NL-15-1777

Vogtle Electric Generating Plant – Unit 1
Completion of Required Action for NRC Orders EA-12-049 & EA-12-051
Mitigation Strategies for Beyond-Design-Basis External Events and
Reliable Spent Fuel Pool Level Instrumentation

Enclosure 3

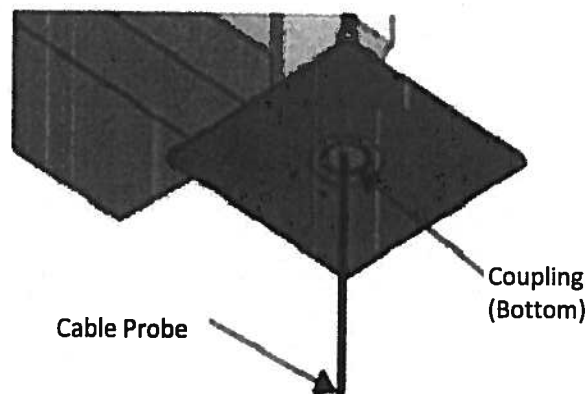
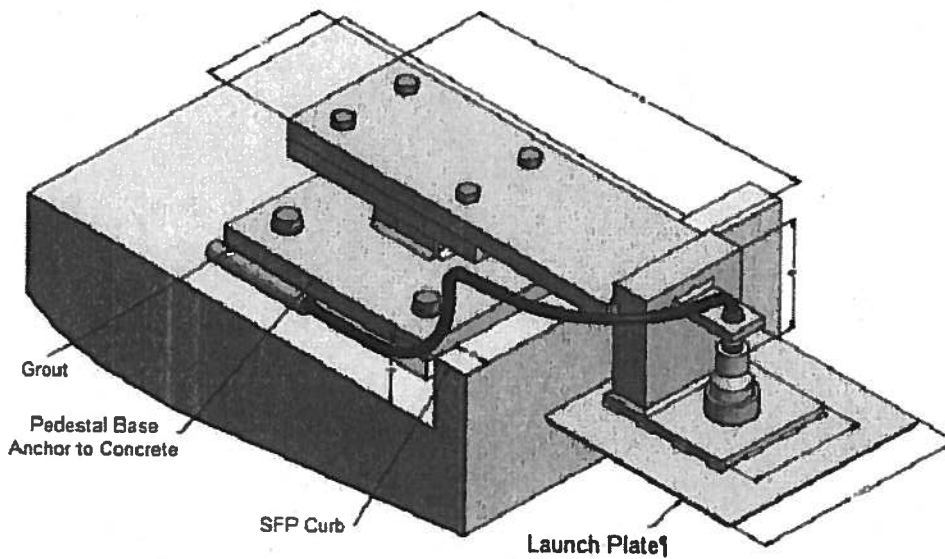
- a) A description of the manner in which the level sensor (and stilling well, if appropriate) will be attached to the refueling floor and/or other support structures for each planned point of attachment of the probe assembly. Indicate in a schematic the portions of the level sensor that will serve as points of attachment for mechanical/mounting or electrical connections.
- b) A description of the manner by which the mechanical connections will attach the level instrument to permanent SFP structures so as to support the level sensor assembly.

- a) The mounting bracket will be attached to the SFP concrete floor utilizing expansion-type concrete anchor bolts. The level sensor consists of a stranded stainless steel cable level probe that is threaded on the top end. The probe attaches (threads) into a coupling that is secured to the mounting bracket launch plate and extends down into the pool. The attachment to the signal cable is via a coaxial connection on the top side of the launch plate coupling.

The simplified drawing below shows a representation of the attachment of the probe and the sensor cable to the mounting bracket (launch plate), and mounting bracket attachment to the SFP structure.

- b) The level sensor (probe) is designed to be attached near its upper end to the mounting bracket, as described in the response to RAI 3a above. The mounting bracket will be attached to the SFP concrete floor utilizing expansion-type concrete anchor bolts. The mounting bracket to the SFP structure concrete floor anchorage is designed to meet the requirements of the Vogtle design and licensing basis for Seismic Category I components including seismic loads, static weight loads and hydrodynamic loads.

Figure 1

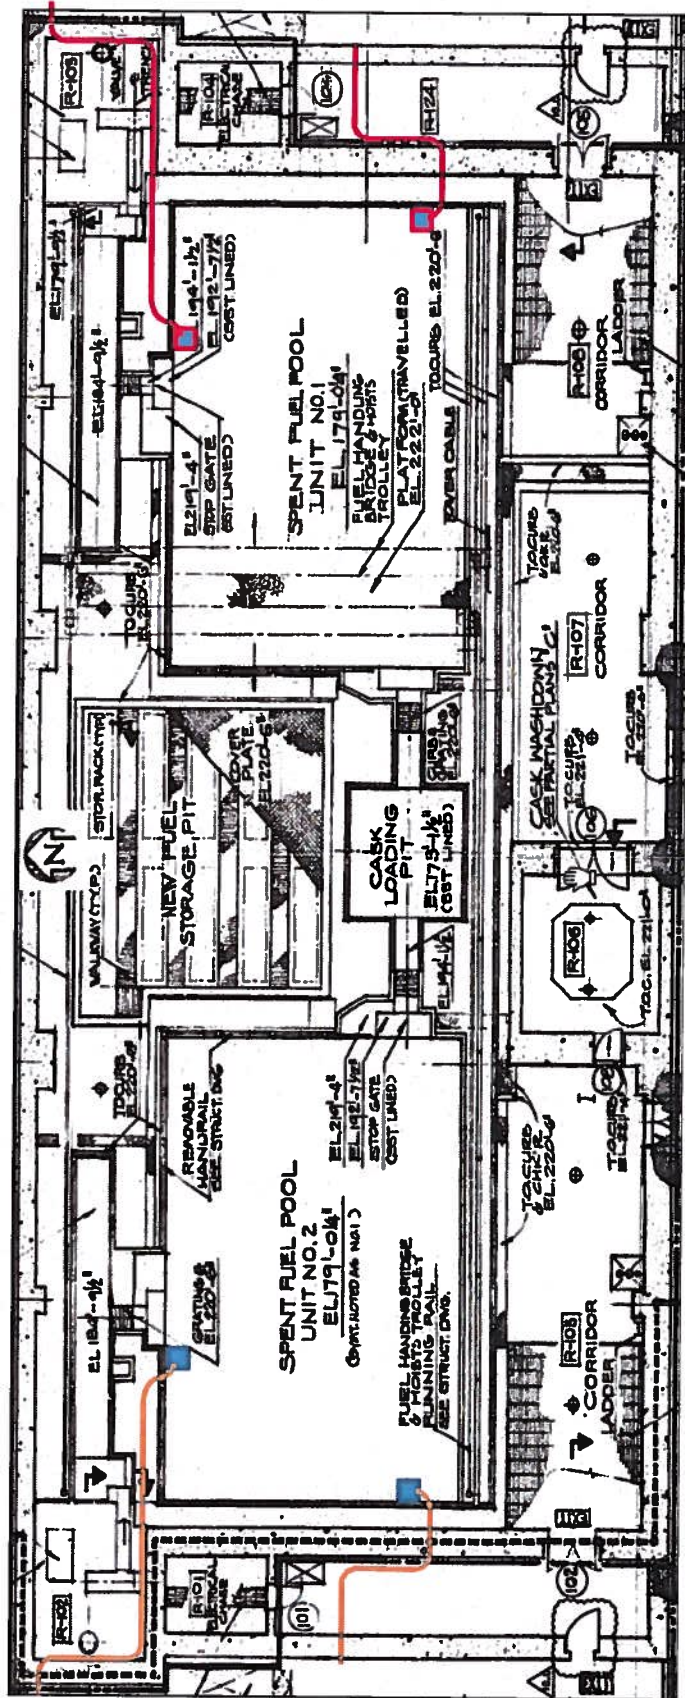
Please provide additional information describing how the proposed arrangement of the guided wave radar and routing of the cabling between the radar probe and the electronics in the unspecified location meets the Order requirement to arrange the SFP level instrument channels in a manner that provides reasonable protection of the level indication function against missiles that may result from damage to the structure over the SFP.

A plan view sketch of the SFP area is provided as Figure 1 (Page E3-9). The sketch depicts the placement of the primary and alternate level sensors, and the routing of cables that extend toward the location of the electronics. Physical separation of the primary and alternate channels to the extent practicable and comparable to the short side of the pool, is used to provide reasonable protection of the level indication function against missiles that may result from the damage to the structure over the SFP.

Figure 2

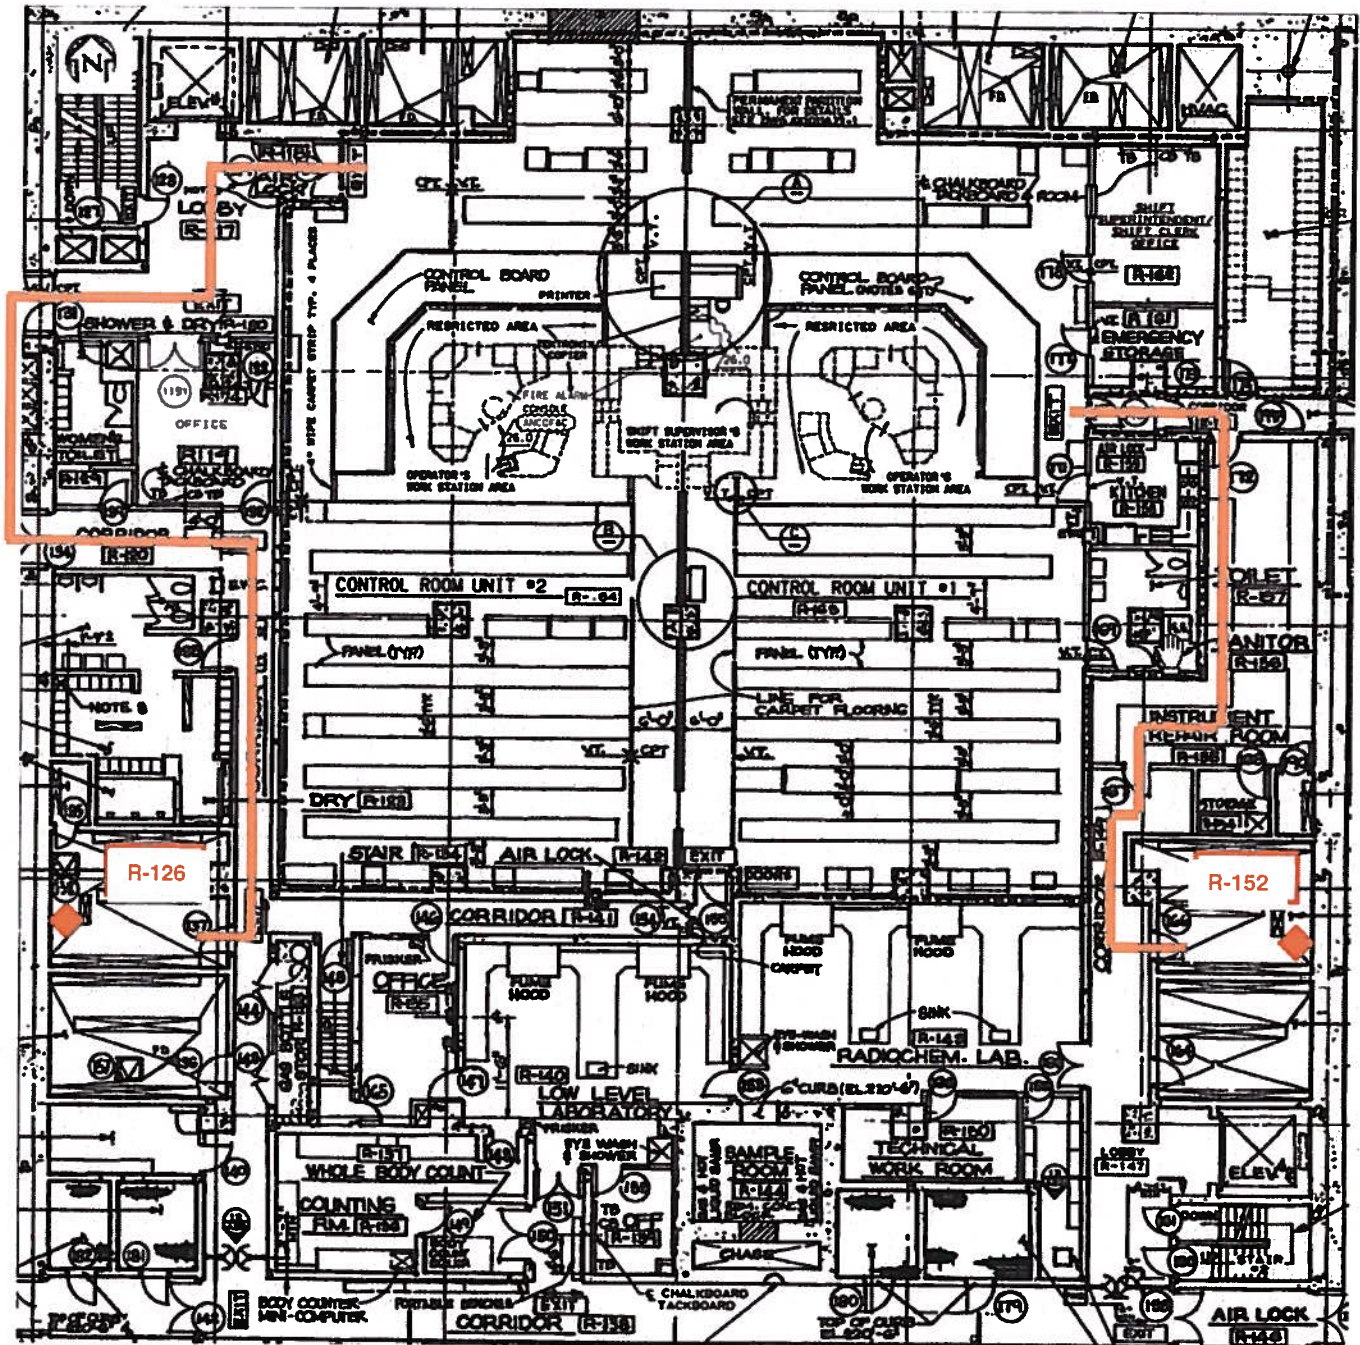
Please provide the following:

- a) See Figure 2 (Page E3-10) for SFPLIS equipment location sketches.
The location of the display panels for VEGP Unit 2 is in room R-126 of the Control Building. The location of the display panels for Vogtle Unit 1 is in room R-152 of the Control Building.
- b) The locations described in response to RAI 11(a) have been evaluated considering the accident conditions described in NEI 12-02 and NEI 12-06, using design inputs from Westinghouse, existing Station Blackout evaluations and NUMARC-8700, *Guidelines and Technical Bases for NUMARC Initiatives Addressing Station Blackout at Light Water Reactors*, dated November 20, 1987.

Building is approximately 100 feet from the East exit of the Control Room. Using a conservative walking pace of 1 mph, the Vogtle Unit 1 and Unit 2 display locations will require less than 10 minutes to access the display location, perform local function and return to the Control Room. Validation performed determined the actual time for Vogtle Unit 2 is 3.5 minutes. With the displays located outside the Radiation Controlled Area, the substantial structures between the SFP and the pathway to the display, combined with the short transit duration, personnel traveling the pathways shown in Figure 2 will not require heroic means with the SFP at Level 3 or above.
